SUBJECT: Transmittal of Westinghouse Responses to US NRC Requests for Additional Information on the AP1000 Application for Design Certification

AP1000 DESIGN CERTIFICATION REVIEW

RAI Number: 440.119 (Response Revision 1)

Figure 440.119-1 Pressurizer Pressure, Loss of RNS in Mode 4 RCS Intact
Comparison of 1 CMT vs 2 CMT Operating

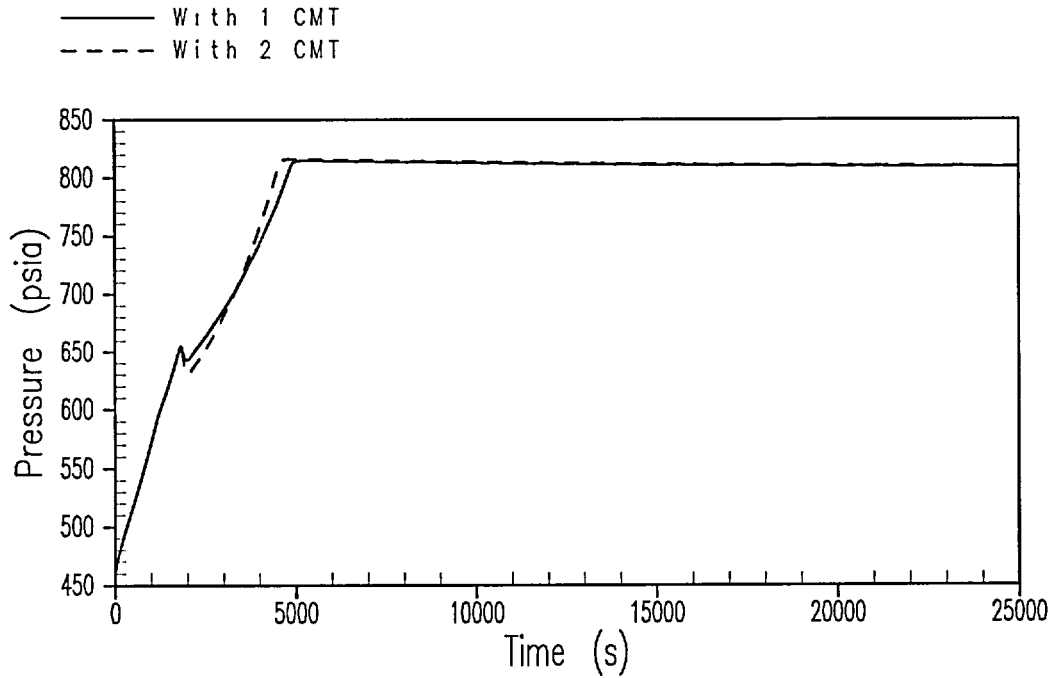
The analysis of a loss of RNS in Mode 4 provided in DCD Appendix 19E is performed assuming both CMT are available. The statement is made in the DCD that the plant response is similar if one CMT is available. Please justify this statement.

In the analysis of the loss of RNS in Mode 4 with the RCS intact, both CMTs were assumed to operate, and the analysis results provided in the DCD Appendix 19E demonstrate the adequacy of the AP1000 passive safety systems to protect the plant in shutdown modes. To confirm the statement made in the DCD Appendix 19E that the plant response is similar for the loss of RNS in Mode 4 considering only one CMT available, an additional analysis has been performed. The attached figures show a comparison of the plant response to a loss of RNS cooling in Mode 4, with only one CMT available. Results show similar plant response for either case, and further
